Invitation to Bid 2022-026

Wildflower Drive Stormwater Drainage Improvements

ADDENDUM NO. 1 – May 20, 2022

Rip Rap Spillway Detail
 Town of Westerly
 Engineering Division
 Westerly, RI 02891

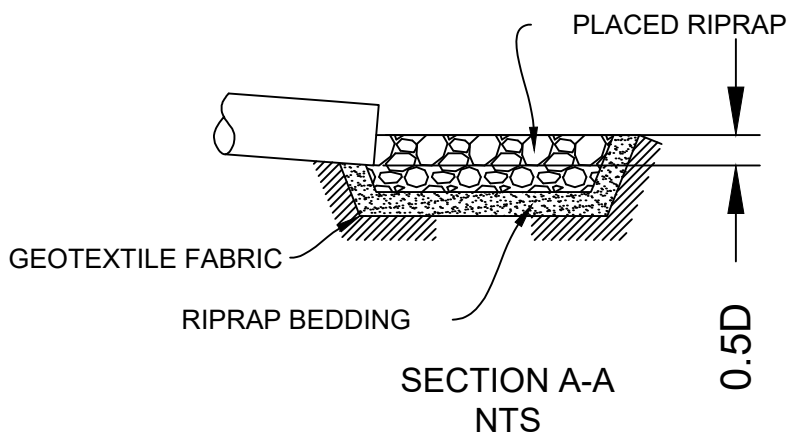
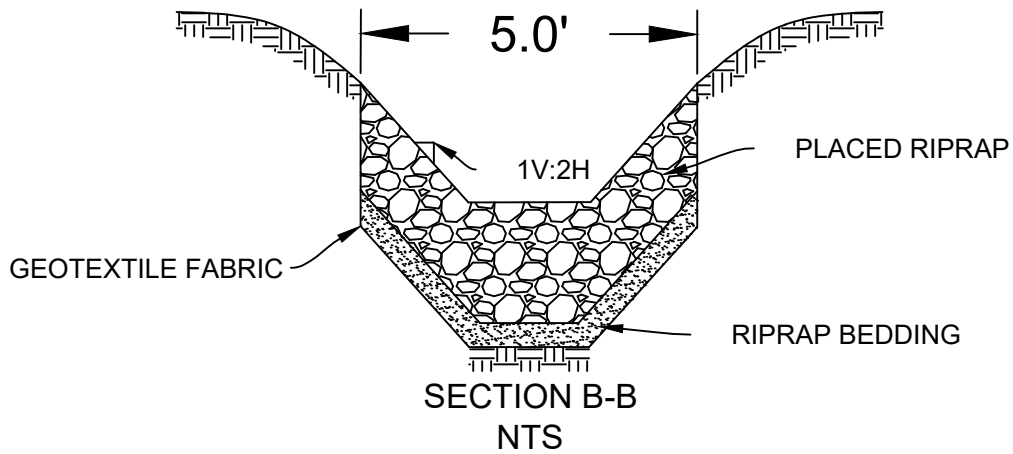
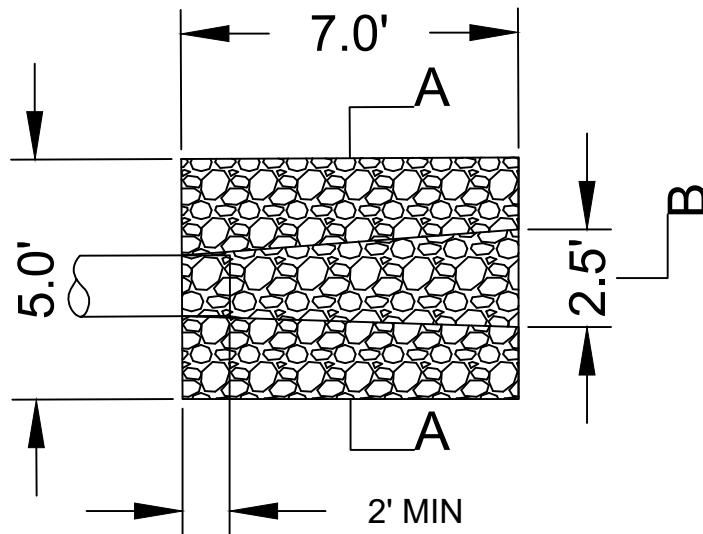
3. Where proposed 15" HDPE pipe ends in a grassed area and not tied into a catch basin i.e. intersection of Wildflower Drive and Argyle Drive, will a flared end or rip rap spillway be required at the outlet of this pipe? If so, how will this be paid for?

Town Response: A rip rap spillway shall be constructed at the outlet of this pipe. Pay items for rip rap and rip rap bedding material have been added to the bid form. The specification for rip rap is attached to this addendum.
